APPLICATION NO.	FILING DATE	FIRST NAMED INVENTOR	ATTORNEY DOCKET NO.	CONFIRMATION NO.
09/841,570	04/24/2001	Gary Boccadutre	1647001	5425

Office Action Summary	Application No. 09/841,570	Applicant(s) BOCCADUTRE ET AL.	
	Examiner Hadi Shakeri	Art Unit 3723

DETAILED ACTION

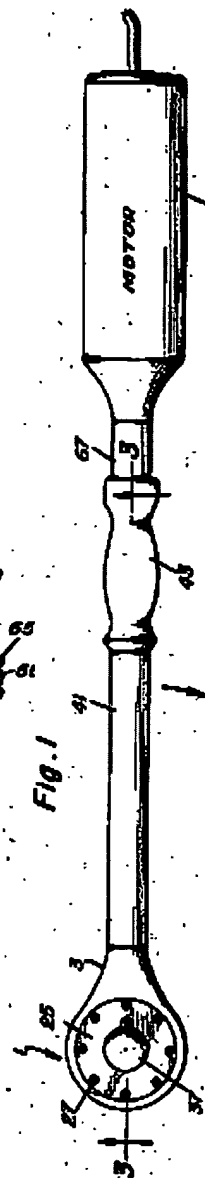
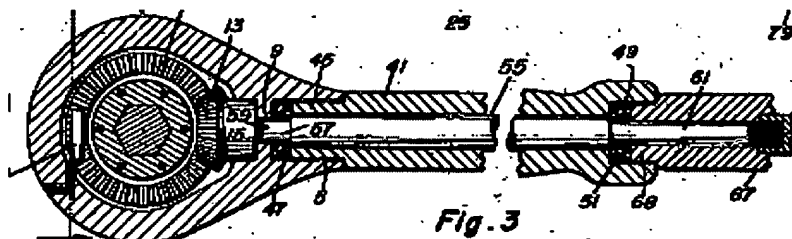
9. Claims 1, 3, 7, 9 and 11 are rejected under 35 U.S.C. 102(b) as being anticipated by Lampke, US Patent No. 2,808,749.

Lampke discloses all the limitations of claims 1 and 11, i.e., power wrench comprising a handle containing a motor; a ratchet extension, (41); a ratchet extension shaft (55); and a ratchet head (1).

Regarding claim 3,
wherein the extension and
shaft are removable.

and 9, wherein the heads and the handle are removable, and the extension and the shaft are "fixedly" attached to the handle and head respectively (fixedly is considered as a fixed attachment and not "unitary").

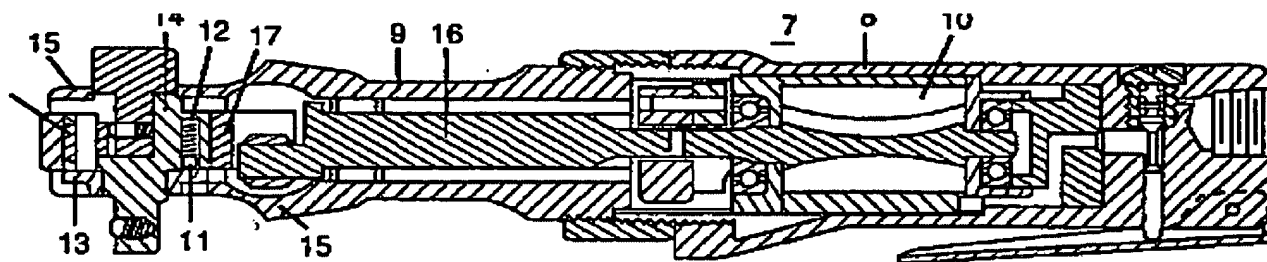
11. Claim 1 is rejected under 35 U.S.C. 102(b) as being clearly anticipated by D' Haem et al., US Patent No. 4,791,836.

D'Haem et al. clearly anticipates claim 1, e.g., Fig. 2.

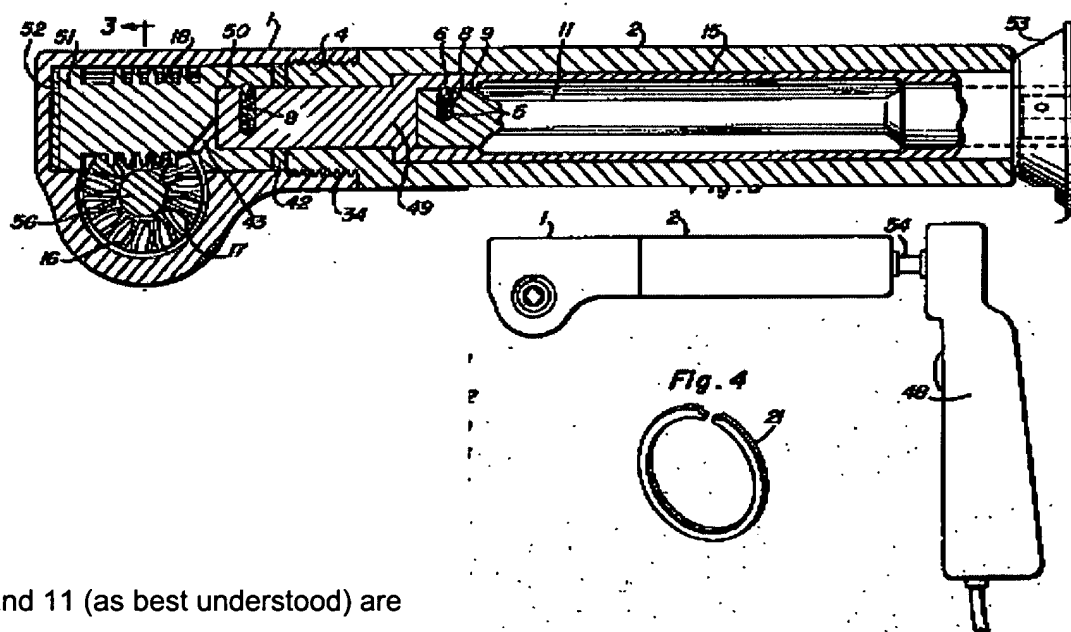
12. Claim 11 is rejected under 35 U.S.C. 102(b) as being clearly anticipated Hendrickson, US Patent No. 3,430,510.

Hendrickson
clearly anticipates
claim 1, e.g., Figs. 2
and 5.

Figure 2

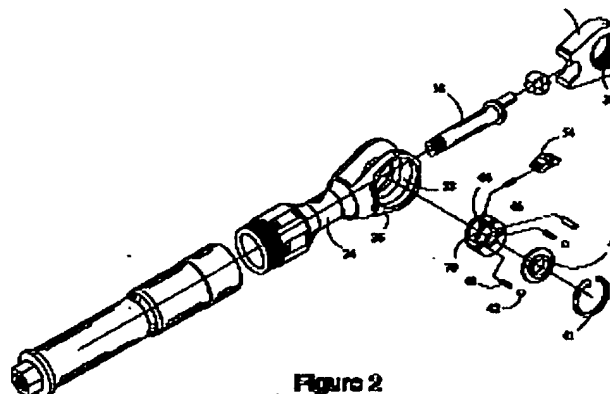
13. Claims 1, 3, 7, 9 and 11 (as best understood) are rejected under 35 U.S.C. 102(b) as being anticipated by Pijanowski, US Patent No. 5,967,002.

Pijanowski anticipates the above claims as best understood, i.e., a handle (23), a head removable from the handle, an extension and an extension shaft (23).
